NORTHWEST SAN PEDRO NEIGHBORHOOD COUNCIL  
COMMENTS ON PONTE VISTA SPECIFIC PLAN

The Board of the Northwest San Pedro Neighborhood Council (NWSPNC) reviewed the draft Specific Plan and Design Guidelines for Ponte Vista and adopted the following initial comments. These comments augment those we submitted on the Draft EIR. Please note that these are initial comments and we reserve the right to add to or alter them.

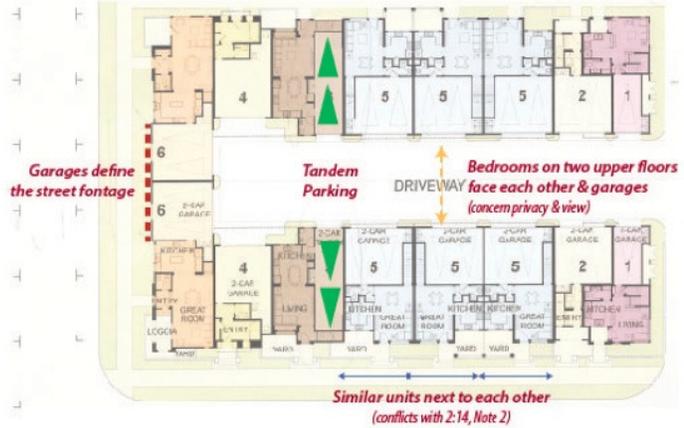
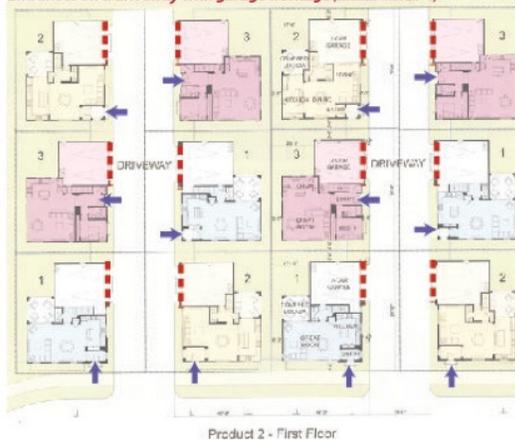
Walls and Fence: The wall and fencing diagram (page 119) shows a “view fence” along the northern most section of the site. The preliminary grading plan (sheet 5) and section L-L and A-A (sheet 9) show extensive grade (40 to 50 feet elevation) and what appears to be a 10 foot tall “retaining wall.” A solid retaining wall is not likely to preserve any views!

Trails: The Open Space Exhibit and associated text indicate that an 8 feet wide perimeter trail will be available for public access. The preliminary grading plan and Section B-B (sheet 9) show a narrow and continuous two-step retaining wall with steep grades. It is not clear where the 8 foot wide trail would fit and where the access point for the public trail would be?

Few recommended residential building types for Ponte Vista

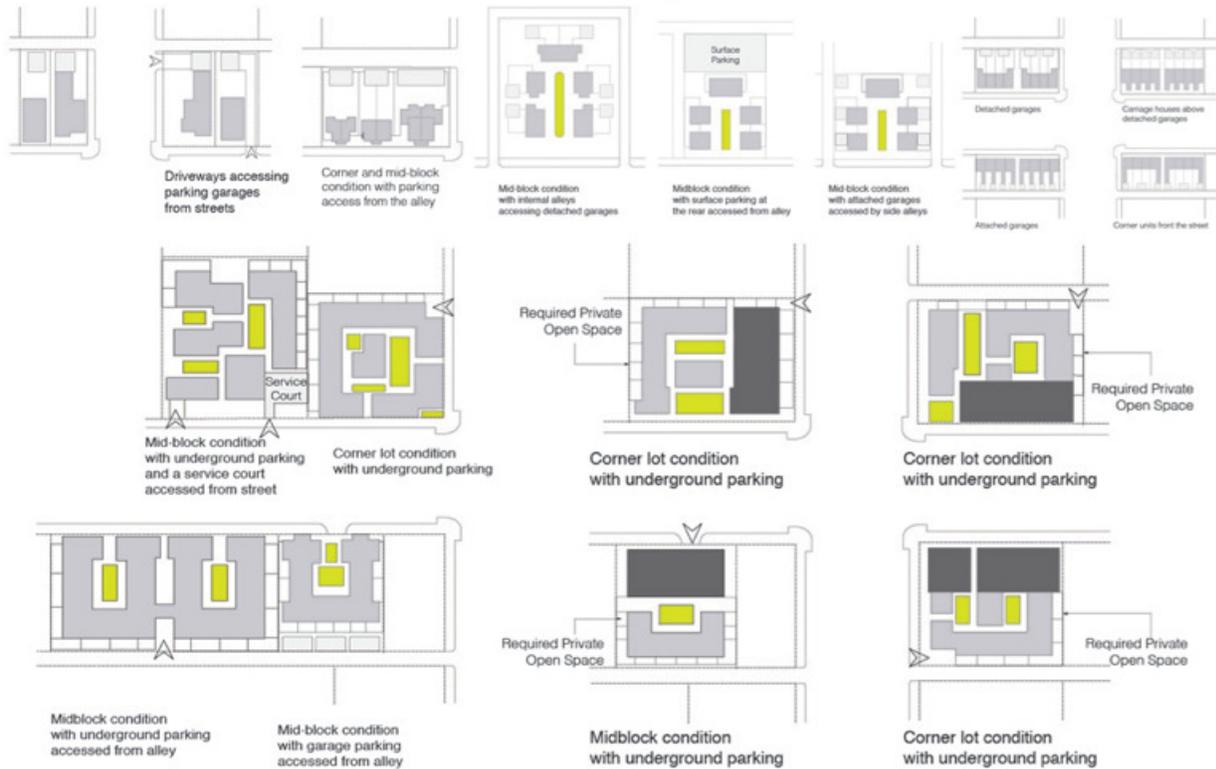
The diagram below shows a range of residential building types that first and foremost address the street but also produce a rich variety of desirable living environments. The range includes building types typically found in Southern California such as single-family residence, duplex, triplex, quads, row houses, courtyard houses, and hybrid court.

The example in the illustration of recommended residential building types for Ponte Vista (lower illustration on the previous page) shows how different building types can be combined on individual blocks around varying street and open space types to respond to changing context.

## Frontage Types for Ponte Vista

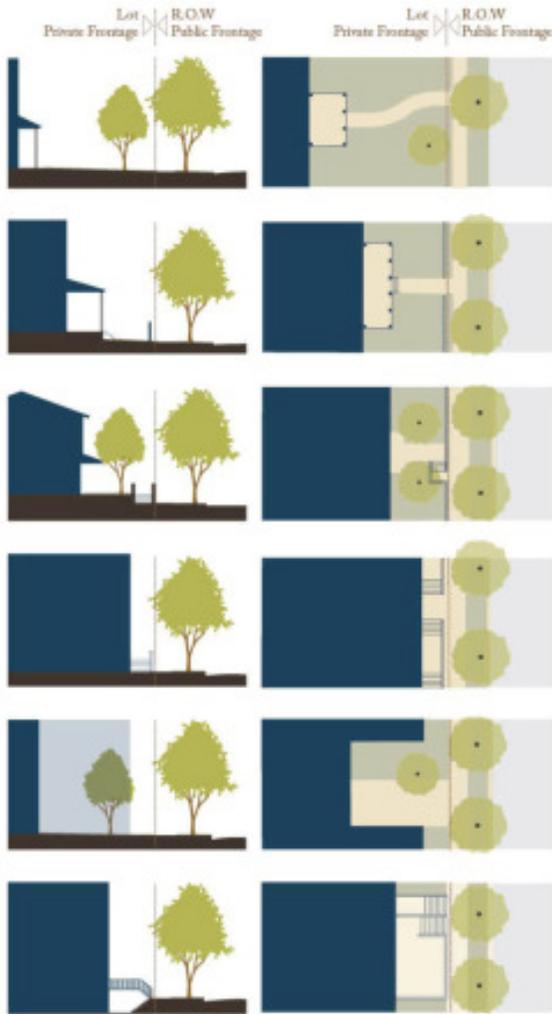
The illustration on the following page shows some residential frontages that make streets walkable. In the current scheme, these frontages are not proposed with consistency to create a walkable environment.
